Log # TXX-96414
File # 10010
909.5
Ref. # 10CFR50.48

SUBJECT: COMANCHE PEAK STEAM ELECTRIC STATION (CPSES) - UNIT 1
DOCKET NO. 50-445
RESPONSE TO SAFETY EVALUATION OPEN ITEMS ON CPSES
UNIT 1 REGARDING THERMO-LAG CABLE FUNCTIONALITY ISSUES
(TAC NO. M85536)

Test Sequence (Figure 1)

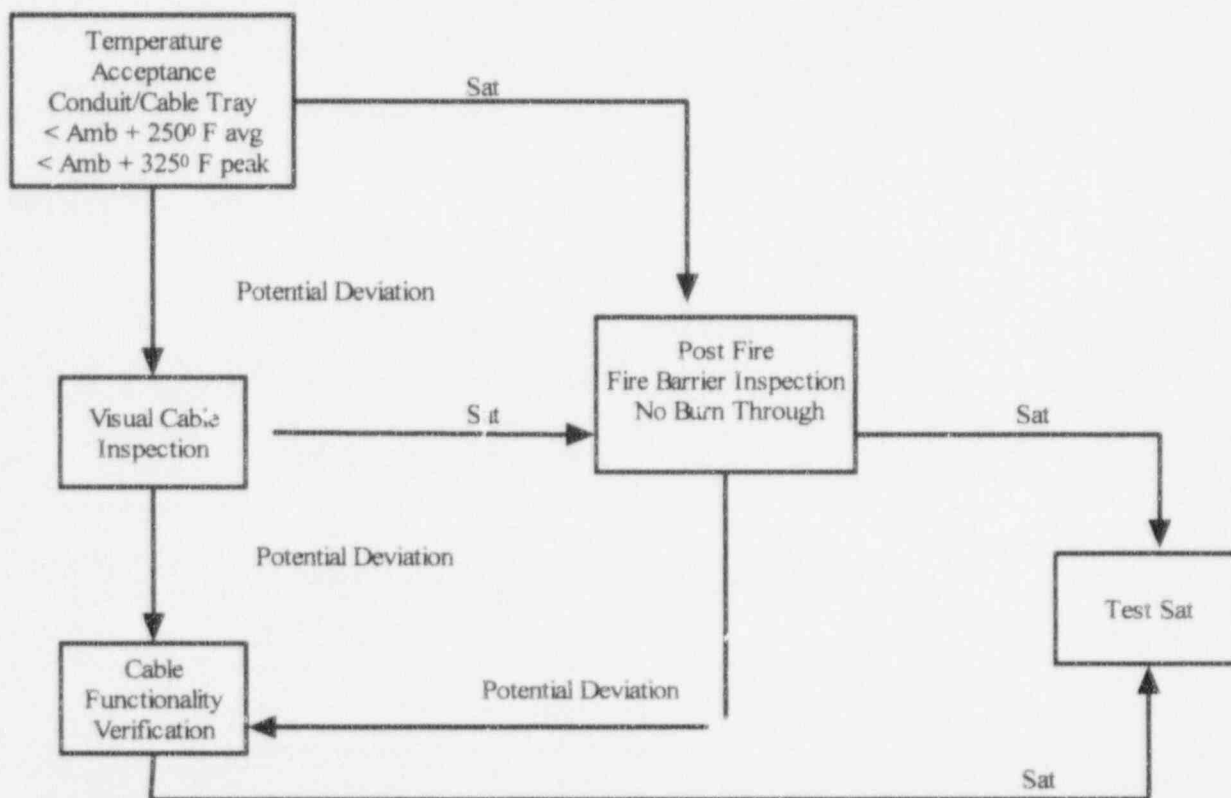
Test Scheme 11-4 did not meet the acceptance criteria for a hose stream test

as specified in the NRC letter dated October 29, 1992. An engineering analysis has not been submitted by TU Electric for NRC staff review to address this unsatisfactory condition. As this configuration has been declared acceptable by the licensee without NRC review and concurrence, the licensee may have deviated from the commitment specified in its September 24, 1992, letter. This issue remains open.

TU Electric asserts that the commitments specified in the September 24, 1992 and the October 29, 1992 correspondence have been met. Via reference 2 TU Electric has previously stated that, "[T]he recognized basis for the hose stream test is to provide reasonable assurance that fire exposure, the barrier system is capable of mitigating significant damage to enclosed raceway elements and cabling where subjected to in-plant fire fighting activities or external objects which may fall during a fire." The test sequence as depicted in October 29, 1992 letter is as follows:

Fire endurance test utilizing Scheme 11-4 was conducted on August 16, 1993. The fire endurance test, hose stream test and cable functionality (Megger) tests were performed to the requirements (acceptance criteria) of the NRC letter dated October 29, 1992 and TU Electric letter dated September 24, 1992 (illustrated in figure 1 above and documented in Omega Point Laboratories Test Report No. 12340-95767).

Scheme 11-4, as tested, met the requirements contained in the NRC letter dated October 29, 1992 and TU Electric letter dated September 24, 1992 for the following parameters:

- a) single point and average temperature increase parameters were not exceeded,
- b) the barrier opened during the hose stream test, however, a visual cable inspection revealed no apparent thermal damage to the conductor insulation, and
- c) the results of the Megger tests were well within the allowable limits
- d) as an additional conservative measure to ensure adequate performance of the installed fire barriers, box-out enclosures of this magnitude in the plant received additional seam reinforcement (stitching, in addition to stress skin), beyond that which was tested.
